City of Alexandria, Virginia

MEMORANDUM

SUBJECT: CONCEPT REVIEW WORK SESSION #3, 1604-1614 KING STREET
BAR CASE # 2016-0419

Figure 5: July 5, 2017 Alternative A top floor

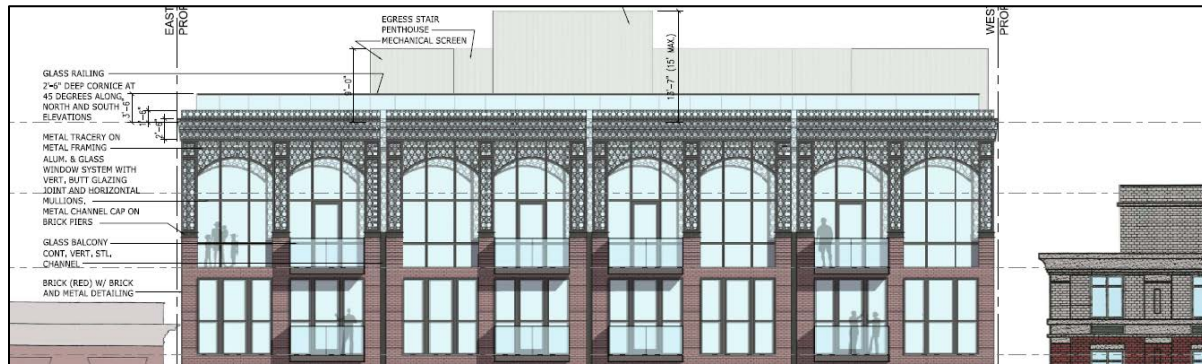
- Base Option (Figure 4) is the applicant's preference. It is similar to the tracery proposal shown at the March 1st BAR hearing. The middle "body" of the building shows the new bay spacing, fenestration and simplified balcony placement, which are the same for Alternatives A & B.
- Alternative A (Figure 5) shows a solid top, which the drawings state are "solid panels on metal framing".
- Alternative B (Figure 6) is a hybrid alternative. It also has a tracery top, but with a surrounding framework simulating columns, segmental arches and a cornice.
- The side and rear elevations of the building utilize the same proposed materials and design scheme, but with no projecting balconies on the side elevations.

Staff supports the overall project, as presented, but strongly recommends a seventh floor design that is closer to Alternative A, and believes that the top should be more refined than currently shown. For instance, while staff believes that the segmental arches are better proportioned than the semi-circular arches and recall late 19th century segmental arches on nearby historic buildings, it is visually disconcerting and not classical tradition for the arches spring from the side of the shaft of the pilaster rather than be supported at the top. Staff recommends that the paired pilasters be shortened so that the arches may spring from their capital and that the area above the arches be enhanced with panels to reduce the scale and provide visual interest.

Staff recommends that the BAR endorse the scale, mass, height and general architectural character of the majority of the proposed new building, as shown in all submitted alternatives, and provide direction that the top of the building have a more solid quality, with final details and materials selection to be reviewed and approved as part of the Certificate of Appropriateness request after approval of the DSUP.

Figure 7: Examples of cast iron building tops

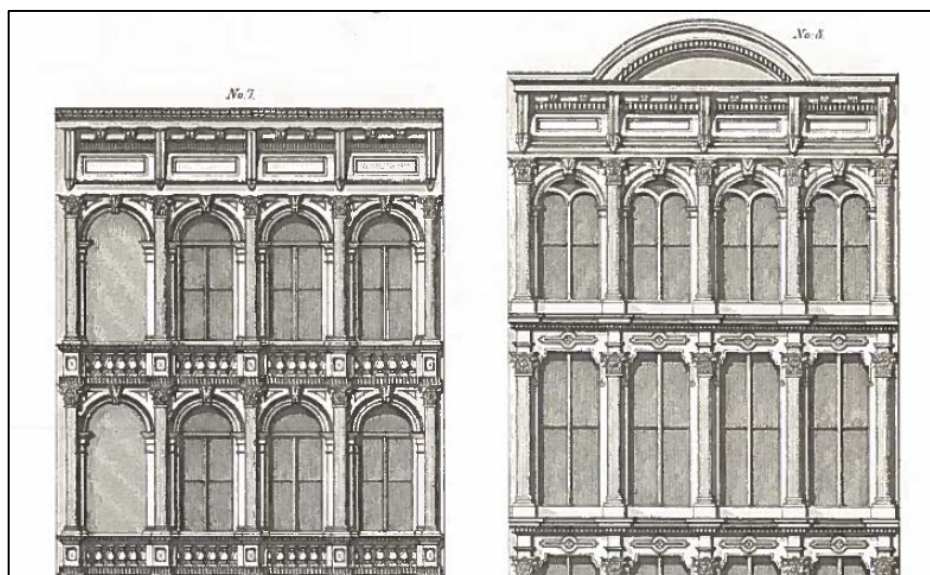
Staff suggests the use of cast stone or metal material for the top floor rather than additional red brick, which could cause the tower to appear even taller than it is. Following the Chicago School style of building, the base, middle and top should be differentiated from each other, in reference to the classical Greek column. Staff recommends that the architect look to historic cast iron architecture for design inspiration. This method of prefabricated construction began in the United State around the mid-19th century and was used primarily on commercial and industrial building. Staff has included a few precedent images below that might provide a jumping off point for a solid top (Figures 7 and 8).
